W. HAWKESBURY CK. & CNR. O'HD  
BRIDGE REHABILITATION  
GENERAL ARRANGEMENT

RE: West Hawkesbury Creek and  
C.N.R. Overhead Rehabilitation  
W.P. 102-86-01, Site 27-50  
Hwy. 17, District 9, Ottawa

Subject: West Hawkesbury Ck. & CNR O'head, Rehab.,  
W.P. 102-86-01, Site 27-50,  
Hwy. 17, District 9

Further to your request of 87 02 04, we have reviewed the general arrangement drawing for the above-noted project, with particular attention to the foundations of the temporary support structure. The following are our comments:

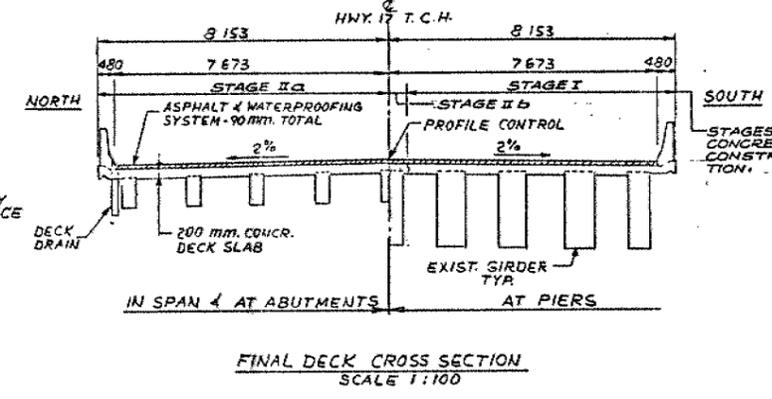
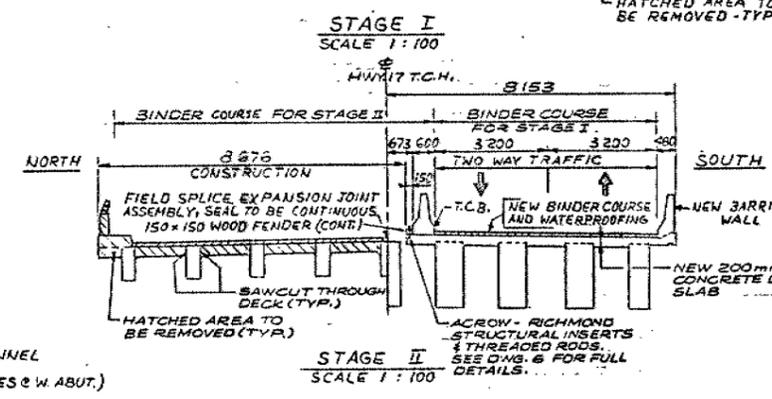
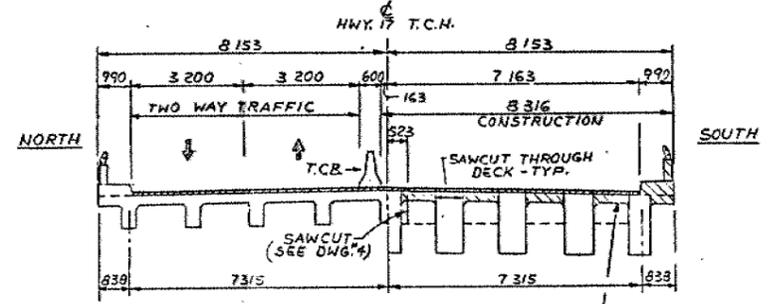
1. We are assuming that since no details have been provided on the general arrangement drawing, the caissons will be founded directly on the limestone bedrock surface, without keying. Since the overburden is relatively shallow (1± m), the caissons can rely only on friction along the base. We believe that since no provisions have been taken to increase the lateral resistance, the lateral loads acting on the temporary support are negligible.

2. A Special Provision will have to be included in the contract documents stipulating that the caissons will have to be removed to at least the creek bed level after completion of the work.

3. If it is more desirable to pour the caissons in the 'dry', consideration could be given to pouring a tremie seal on the bottom of the steel liner. Once the seal sets, the water within the liner could be pumped out and ready-mix concrete could be poured into the liner.

Further to your memorandum of 87 01 22, we have reviewed the temporary support system as shown on the General Arrangement Drawing for the above-noted project, and further to our conversation of 87 01 30, we have the following comments.

We have reviewed the available subsurface information obtained from a 1954 investigation carried out at this site. In the vicinity of the west abutment, the native material consists of 1.7± m of loose sand, underlain by 1.5± m of compact till and in turn, underlain by limestone bedrock. In the vicinity of the east abutment, the native material consists of 3 to 4 m of very dense till, underlain by limestone bedrock. A copy of the original soil stratigraphy is attached for your information.

As indicated in the stratigraphy, no subsurface information is available for the area within the creek bed. However, it is anticipated that the bedrock surface may be found at or about Elev. 47.

In order to support the overhead structure during the rehabilitation work, it is proposed to use 4 temporary supports founded on compacted granular pads. The load applied to each temporary support will result in a stress of 110 kPa at the base of the proposed 1 m wide concrete footing.

With regards to the 2 supports within the creek channel, we suggest that consideration be given to the removal of 1 m± of material composing the creek bed and subsequently constructing the well-compacted granular pads directly on the bedrock surface. Forward and side slopes of the compacted granular fills should be constructed not steeper than 1.75 H:1V. In view of the relatively narrow creek cross-section, this scheme would require the channelization of the creek through a pipe.

The proposed east and west temporary supports require that granular pads be constructed on existing slopes. In the case of the west support, the granular pad will be founded on fill material. In order to confirm the design loads required, a subsurface investigation will be necessary. Without a detailed investigation, nominal loads of up to 50 kPa may be used.

In addition, the east and west temporary support granular pads will have to be constructed with front and side slopes of 2H:1V in order to minimize the potential instabilities of the existing slopes. Details can be discussed if necessary.

As an alternative, all of the temporary supports may be supported on concrete caissons founded on the relatively shallow bedrock surface. If this option is utilized, a field investigation would not be required as information regarding the bedrock surface location is available from the 1954 investigation. For 600 mm dia. caissons founded on the limestone bedrock, a ULS loading of 1700 kN per caisson is acceptable. A beam could be horizontally supported on the caissons, and in turn, the temporary structure supports could be founded on the beam.

We have reviewed the preliminary General Arrangement Drawing 27-50/R-P1 for the above noted structure and note that the project involves only rehabilitation of deck.

In view that the proposed work does not include any disturbance of the footings or the area surrounding them, we do not have any comments. However, if the rehabilitation increases the load on the foundation elements, this Section should be informed.
